**TRANSMITTAL OF THE EXPLANATION OF SIGNIFICANT DIFFERENCES TO
THE RECORD OF DECISION FOR THE INTERIM REMEDIAL ACTION OF THE
NORTHWEST PLUME AT THE PADUCAH GASEOUS DIFFUSION PLANT,
PADUCAH, KENTUCKY (DOE/LX/07-0343&D2)**

1. Certification Page
2. D2 ESD to the ROD for the Interim Remedial Action of the Northwest Plume
3. Red-lined D2 ESD to the ROD for the Interim Remedial Action of the Northwest Plume
4. Comment Response Summary

Document Identification: *Explanation of Significant Differences to the Record of Decision for the Interim Remedial Action of the Northwest Plume at the Paducah Gaseous Diffusion Plant, Paducah, Kentucky, DOE/LX/07-0343&D2*

Figure 2. TCE in the Regional Gravel Aquifer in the Vicinity of PGDP, 2009

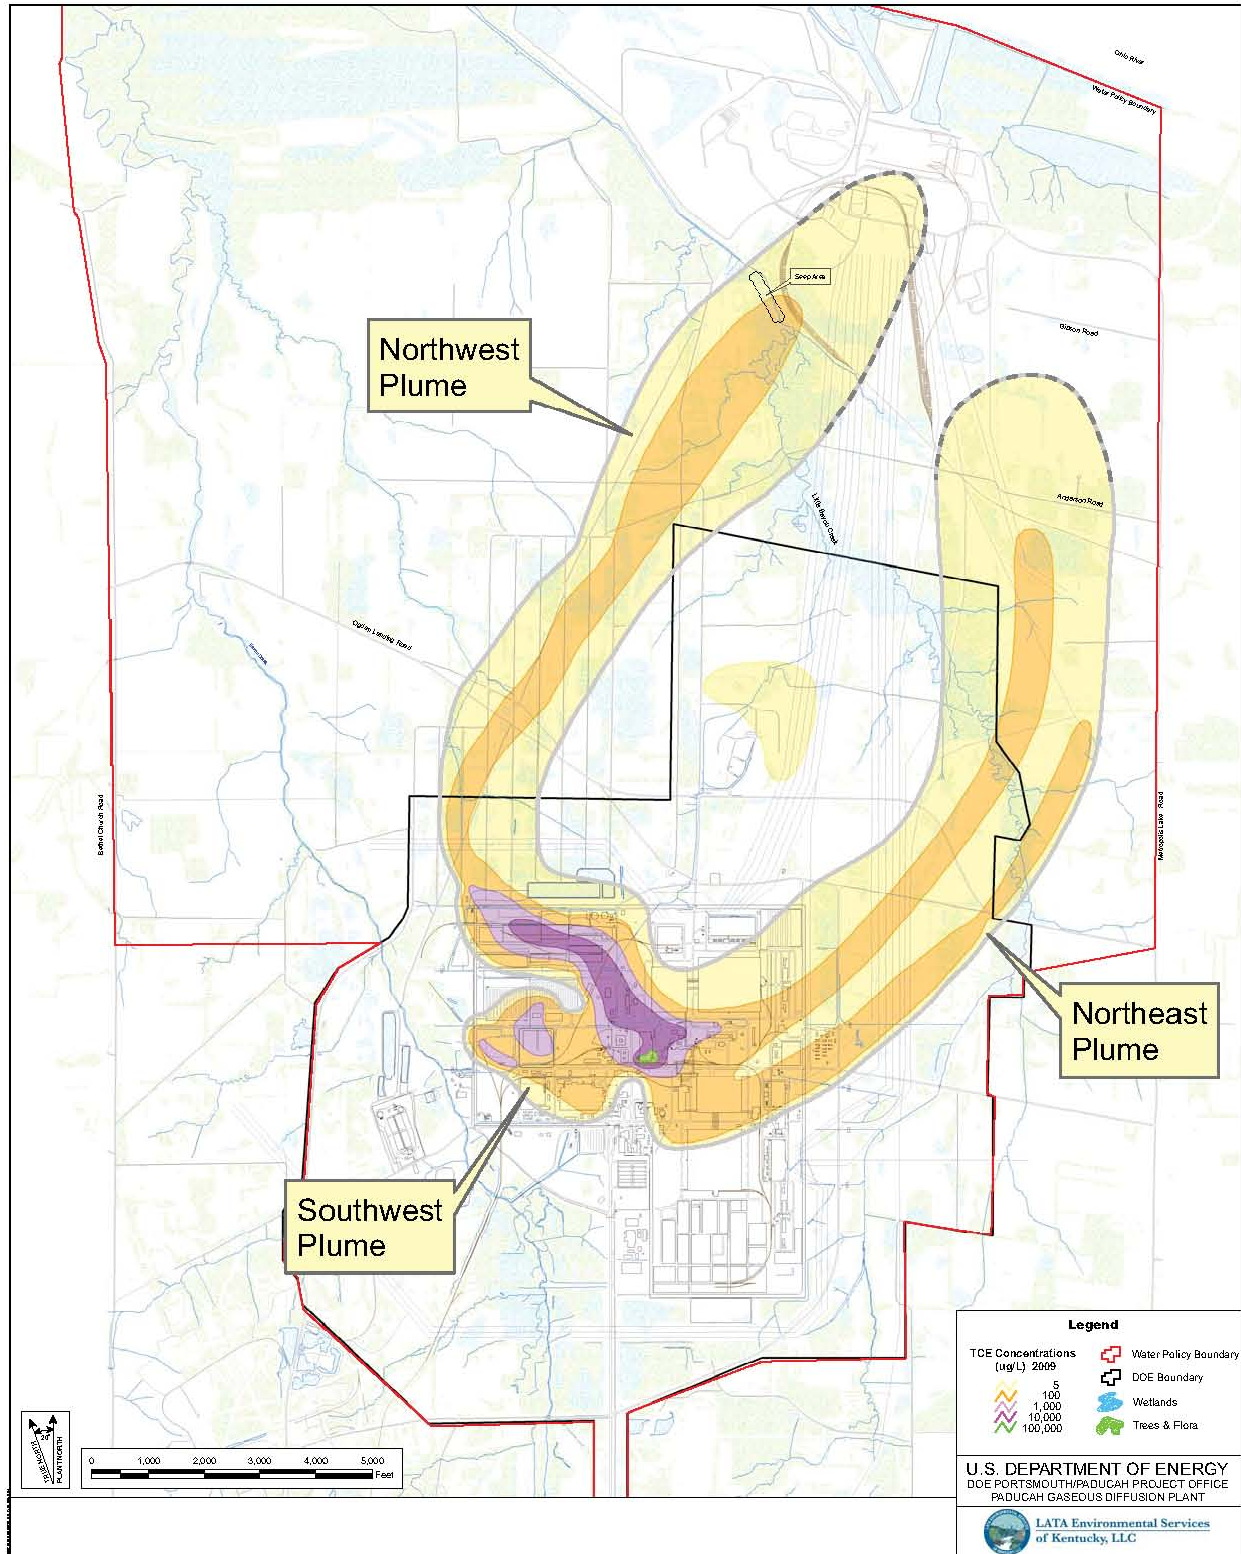
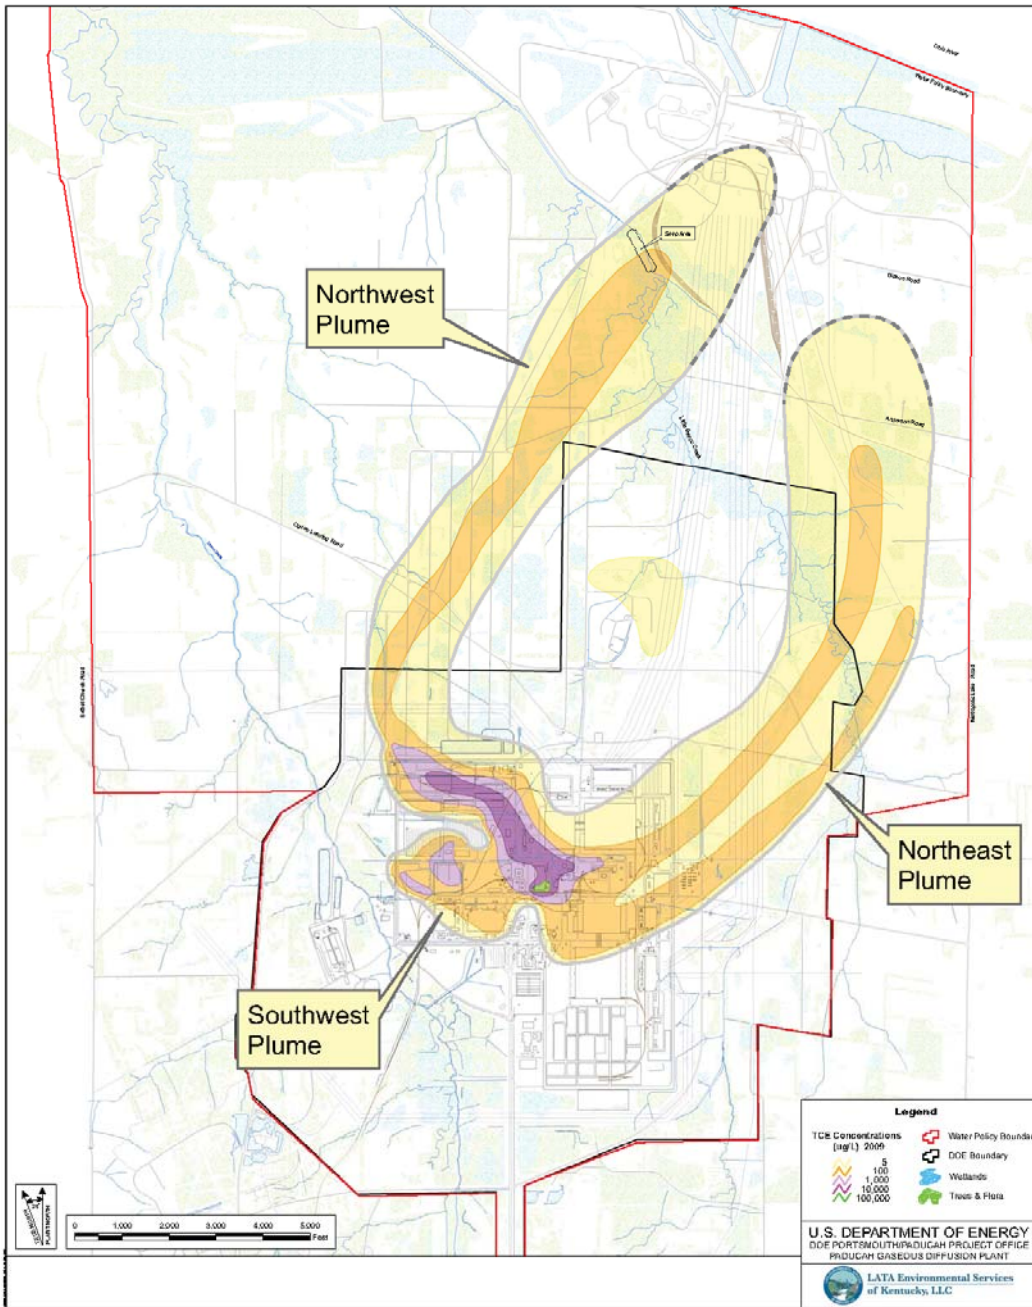
Comment 2: Figures 2 & 3: Figures 2 and 3 should be based on the 2009 ground water data, which was collected largely in response to the evaluations and reports on which this document is based.

Response 2: Figure 2 has been replaced with the 2009 version of the plume map, as requested. Also, Figure 4 has been replaced with the 2009 version of the plume map. Figure 3, however, is a map of the plume as understood in 1994 and is shown to provide a comparison to the plume as currently understood; therefore, Figure 3 was not replaced. The text of Section 2.1 has been modified to be consistent with the figures as follows: "Figures 3 and 4 provide a comparison of the TCE plumes between 1994 and 2009 (the latest available plume map)."
